Seismic Walkdown Checklist (SWC)

Project: Braidwood 1 SWEL

1DC04E (NP 6695 crack) 7-16-12 063

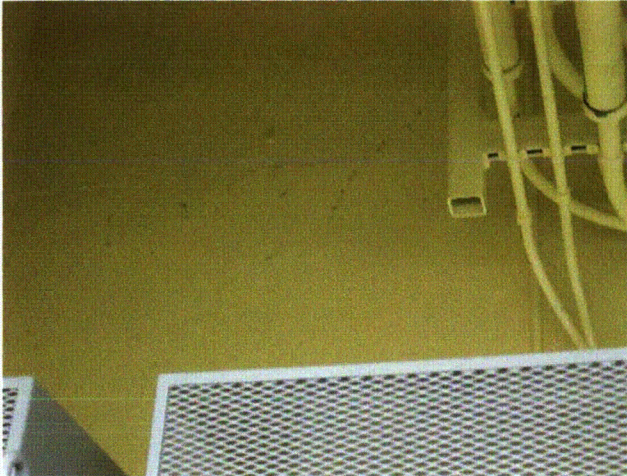
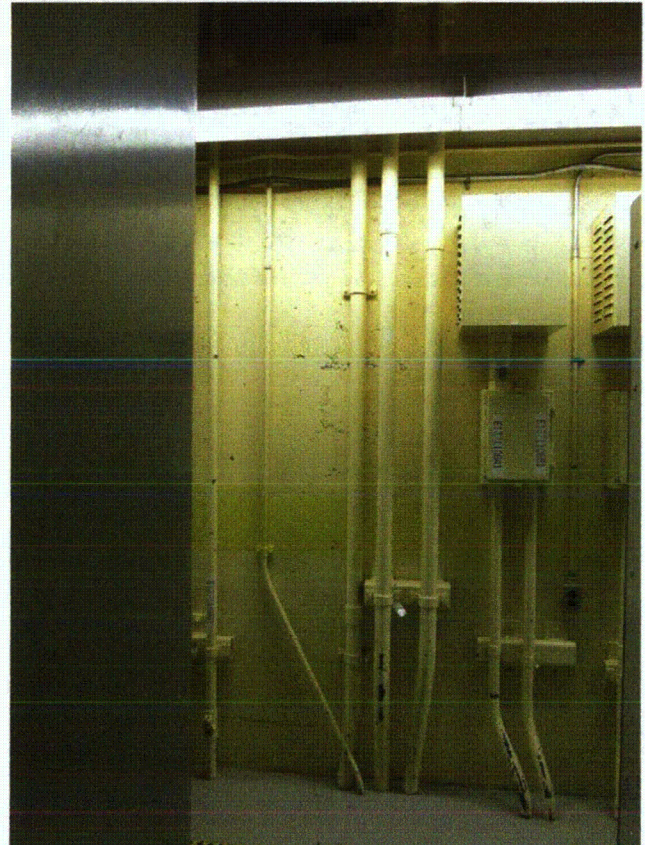
11. Have you looked for and found no adverse seismic conditions that could adversely affect the safety functions of the equipment? Yes
See AWC 8 for discussion on small crack in wall near equipment.

1DG01KB (AWB - thread engagement) 7-18-12 050

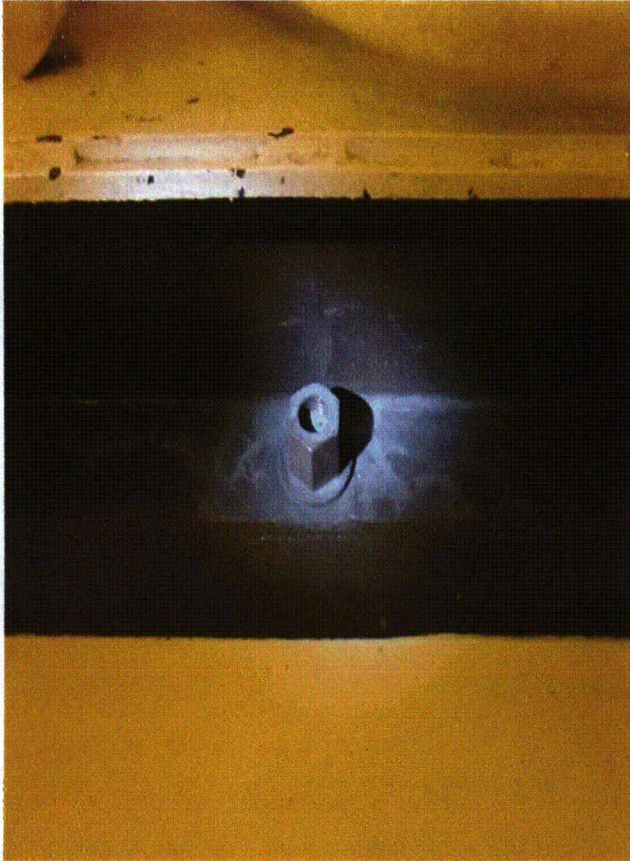
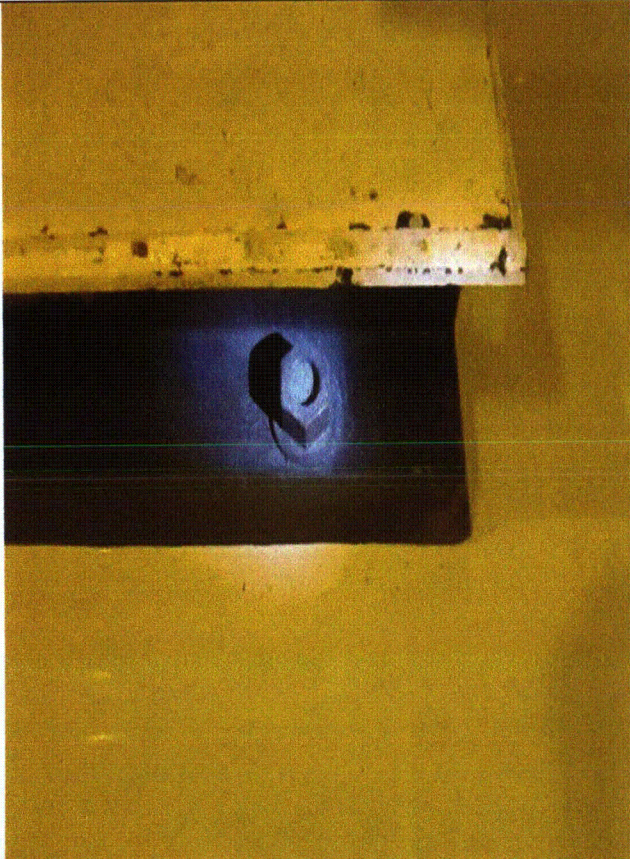
5. Is the anchorage configuration consistent with plant documentation? (Note: This question only applies if the item is one of the 50% for which an anchorage configuration verification is required.) Yes
M-1222 Sheet 11 Revision D
See AWC 11 for thread engagement of heat exchanger skid.

1DO01TB 7-16-12 091

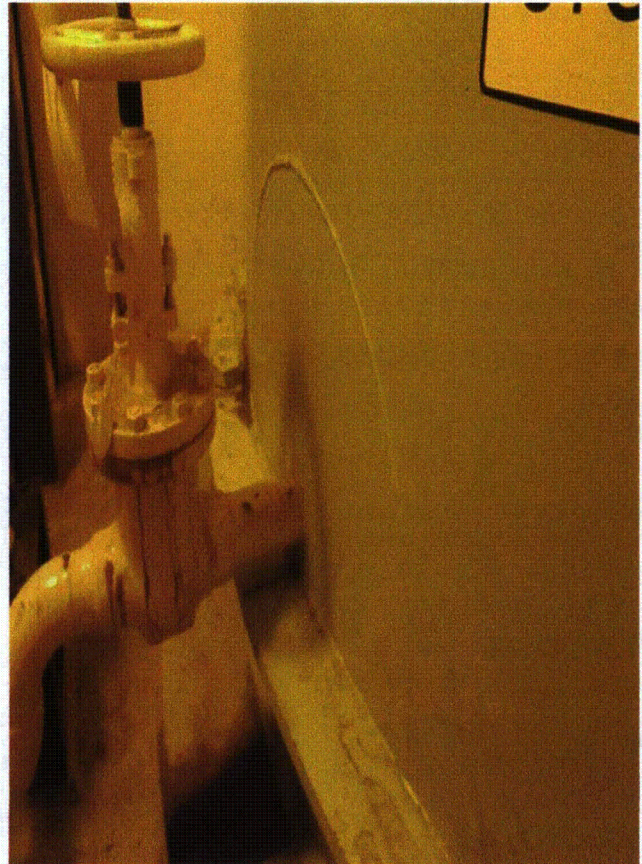
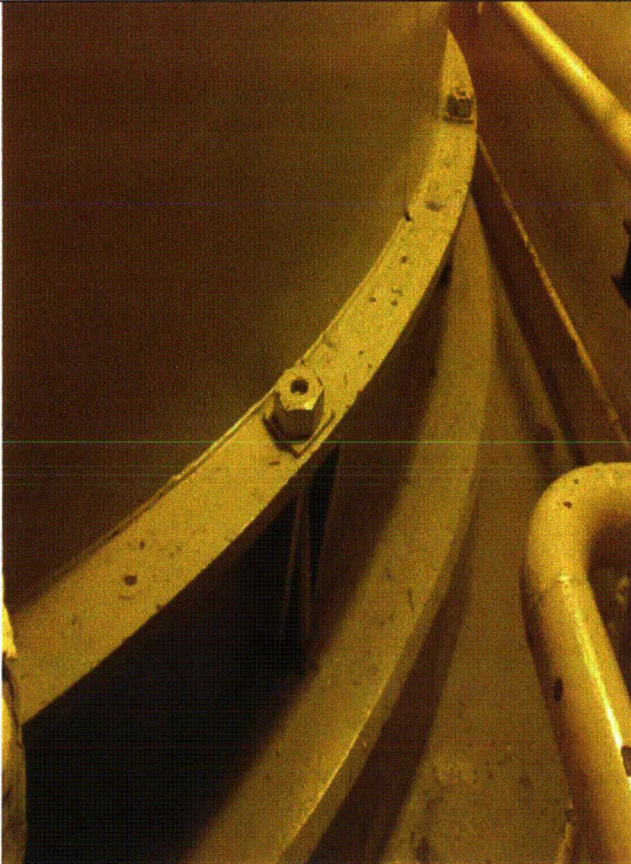
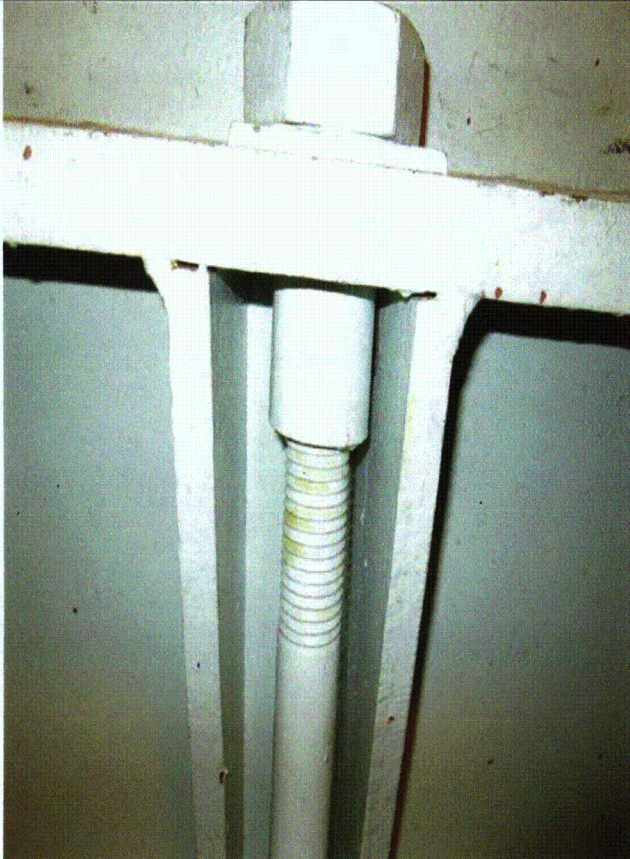
4 of 12 anchor bolts have hairline cracks in the 1'thick foundation pad that do not extend into the base slab. A review of the design drawings was performed. The tank locations are shown on Drawing M-1216 Sheet 1 Revision W. The anchor bolt locations and details are shown on Drawing M-1214 Sheet 3 Revision Z. The anchor bolts are embedded 1'-3 1/2" in the base slab. The approximate total length of the anchor bolts is 3'-9". The pad is shown on section G-G shows a #6 reinforcing bar outside of the anchor bolt that will provide confinement to the anchor.
